August 31, 2020

Memorandum: SAG Review of Draft ARWP 8-1-2020

Scientific Advisory Group (SAG)

Figure 1. Suggested locations of new dust mitigation treatments in south-central ODSVRA for the 2020-21 work plan.

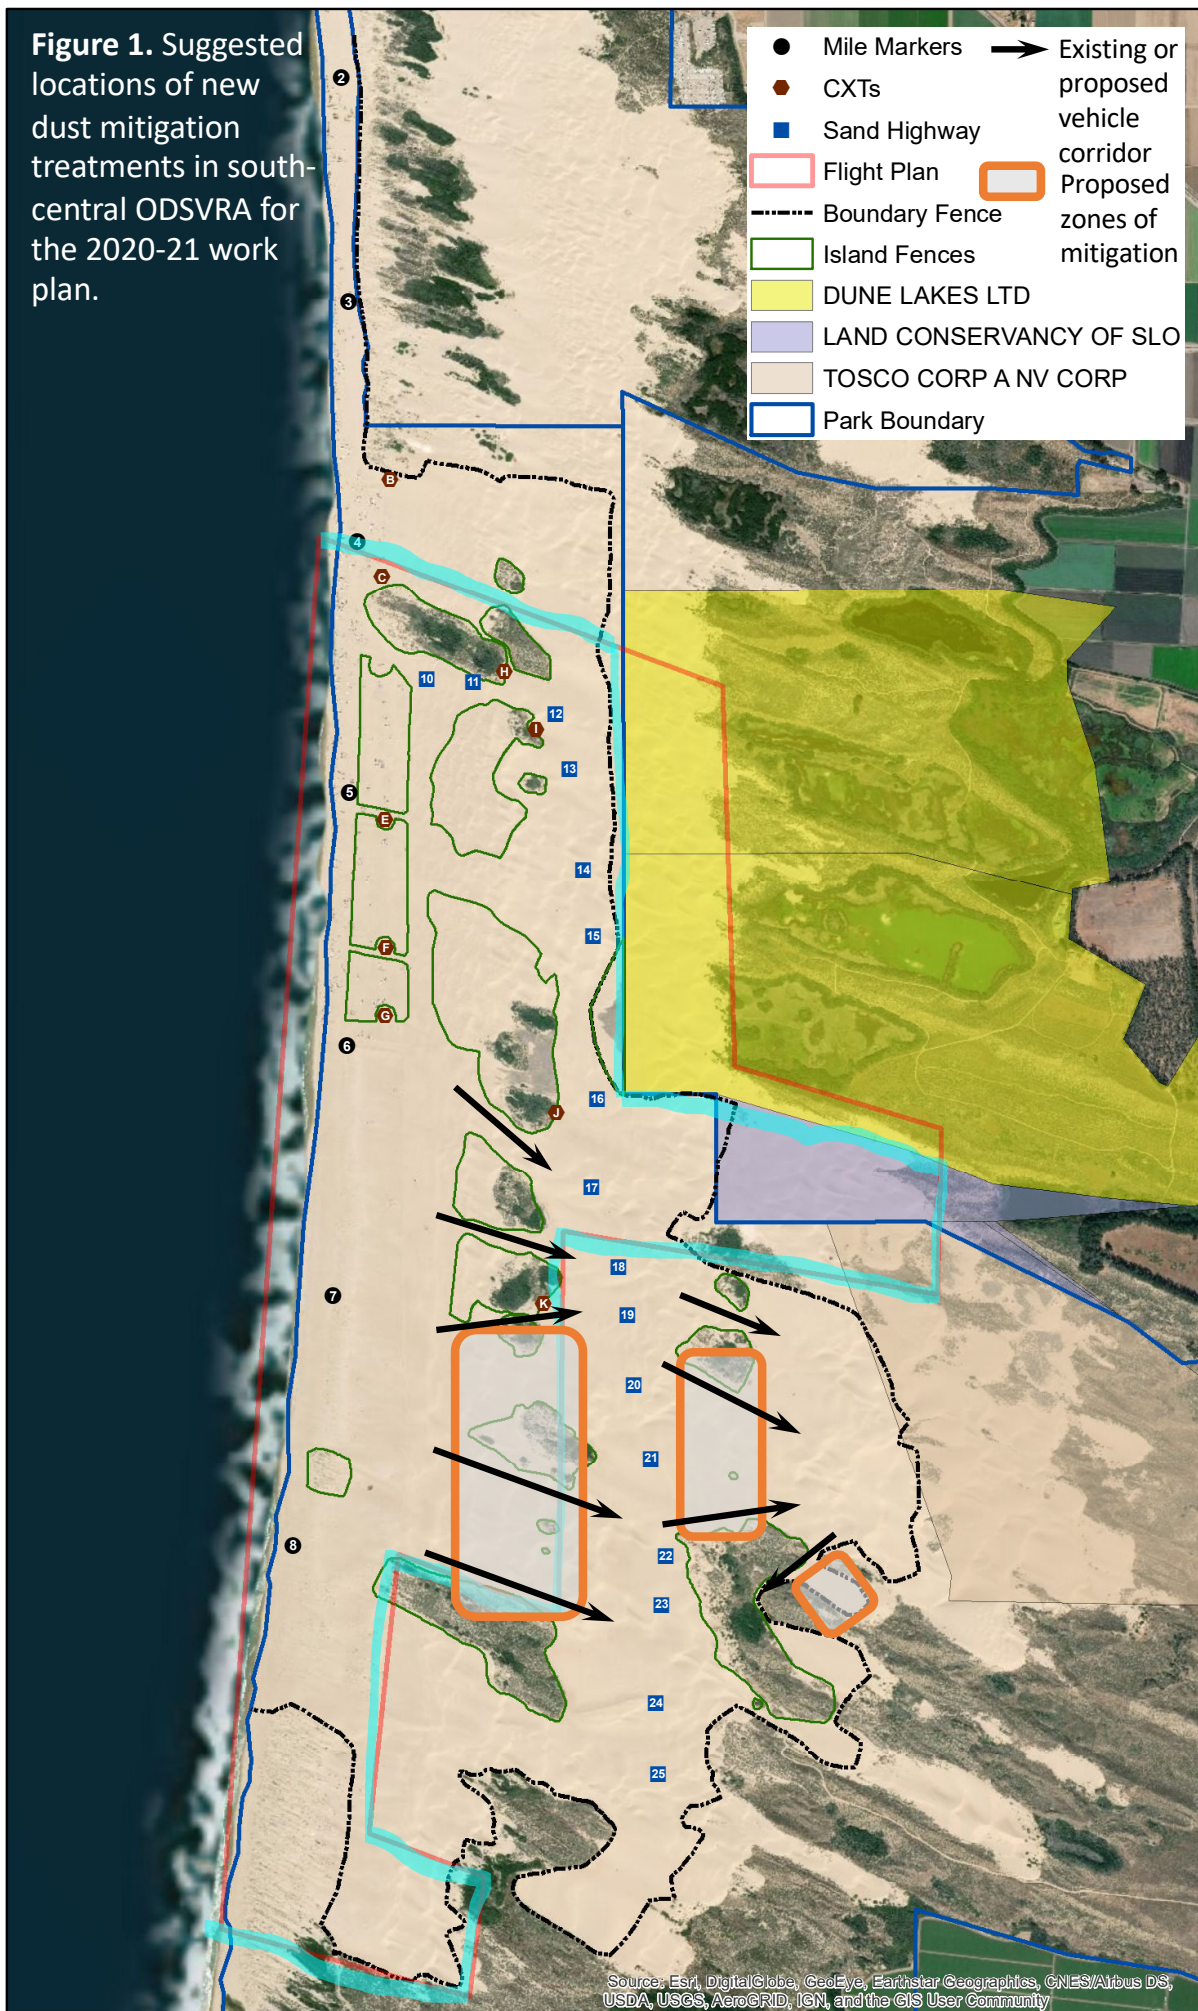
The SAG is aware that the draft ARWP proposes to add only 40 acres of additional dust mitigation treatments in the 2020-21 work year, which may be insufficient to achieve the level of dust mitigation required by the Stipulated Order of Abatement (SOA) in a timely manner. The SAG therefore recommends that the 2020-21 ARWP plan for an increase in the amount of new dust mitigation treatment areas beyond the 40 acres stated in the draft ARWP to at least double this amount. To inform this recommendation, the SAG reviewed a map of existing (to February 2020) dust mitigation treatments as well as the most current Desert Research Institute (DRI) dust emission attribution maps (based on 2013 winds and the PI-SWERL testing grid) for both the CDF and Mesa2 monitoring stations. Noting extensive recent dust mitigation efforts in the north-central portion of the Oceano Dunes State Vehicular Recreation Area (ODSVRA) (e.g., BBQ Flats, Bigfoot, Eucalyptus) the SAG recommends that OHMVR focus on installing new mitigation "islands" in the south-central region of the ODSVRA, as shown in the attached Figure 1. Such areas could have additional emissions reductions benefits for Mesa2, in particular.

The SAG recognizes the challenges imposed by the terrain and other site logistics, such as maintaining safety, restroom access, and vehicle transport corridors, and indicates three general areas for consideration. Although these areas do not correspond with the most highly emissive surfaces attributed to PM10 concentrations at either Mesa2 or CDF (see attached Figures 2 and 3), such as the "sand highway," they would provide dust mitigation benefit not only within their footprint areas but also by a sheltering effect that would reduce surface shear stress, sand saltation, and resulting dust emissions downwind of the treatment areas. Possible locations for transportation/access corridors to accompany these mitigation islands are also indicated in the attached Figure 1.

Figure 3. General locations of recommended dust mitigation treatments for the 2020-21 work plan shown overlain on the map of source attribution to the CDF monitoring station. Produced by DRI using 2013 data.

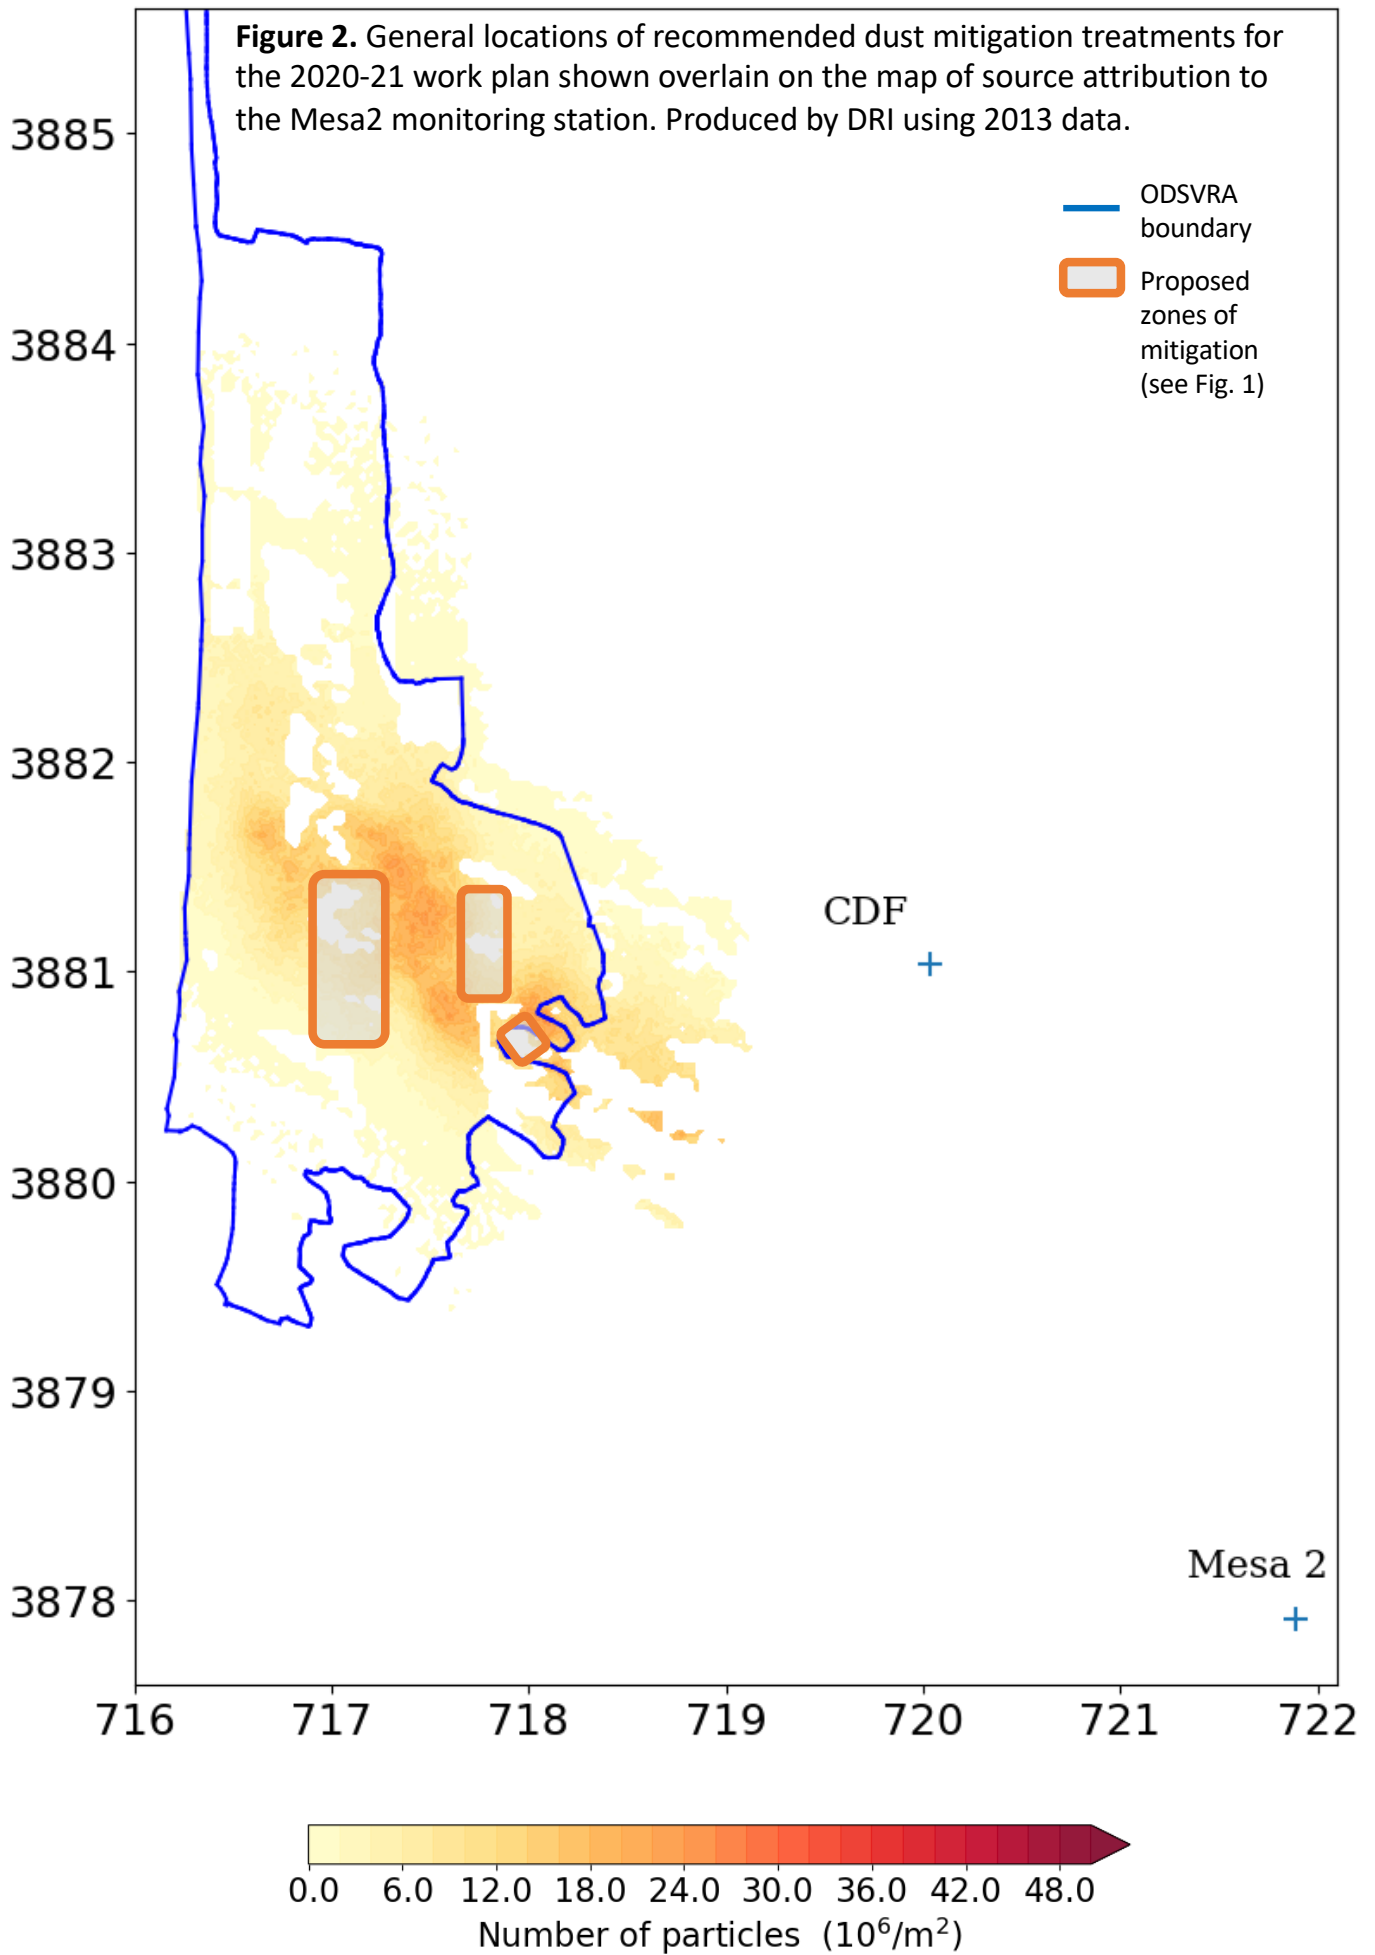
Members of the SAG offer additional specific comments on the draft ARWP below. Three figures are also attached with this review.
